Petition 175PDA-06 PB, Legislative Matter No. 060735 City Plan Board and Staff Conditions January 18, 2007 (Words <u>underlined</u> are additions made by Plan Board.)

SUBJECT:Petition 175PDA-06 PB.Frederick L. Henderson, agent for James D.
Henderson, II, Oak Point Office Park. Re-establish an expired PD with
modified PD layout plans for an office development. Zoned: PD (Planned
development). Located at 3501 South Main Street.

Petition No. 175PDA-06PB Review Date: November 16th 2006

Petition No. 175PDA-06PB Review Type: Planned Development Review Date: 11/7/06 Review For :Plan Board Plan Reviewed: 11/7/06 Description, Agent & Location: Frederick L. Henderson, Oak Point Office Project Planner: Lawrence Calderon Park, 3501 S Main Street DISAPPROVED APPROVABLE CONCEPT SUBJECT TO COMMENTS This site plan has been reviewed for compliance with Chapter 5 of Comments By: the Standard Building Code & for accessible routes of the Florida Brinda . Accessibility Code for Building Construction. Complete code compliance plan review will be performed at Building Brenda G. Strickland Permitting. Plans Examiner **REVISIONS / RECOMMENDATIONS:** This submittal was reviewed for PD amendment and layou

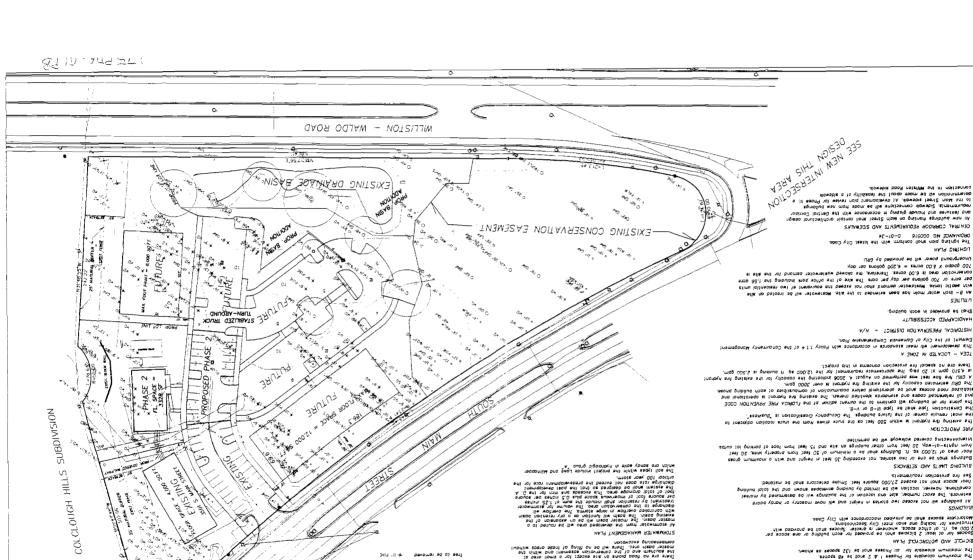
- 1. Building envelopes should be dimensioned and tied to external property boundaries.
- 2. Hard surface areas shall be designated to allow for turn-around at the end of the proposed Phase II.
- 3. Please show location of buildings on adjacent lots in Colclough Hills Subdivision.
- 4. Please ensure that there are no encroachments within the designated setbacks.
- 5. The marked up ordinance submitted with the application has been reviewed and all relevant standards included as new conditions in the new Planned Development report.
- 6. At the time of development plan review, the landscaping buffer along the single family residential shall reviewed by the City Arborist to determine whether it meets the buffer criteria. Additional vegetation may be required to supplement existing vegetation.
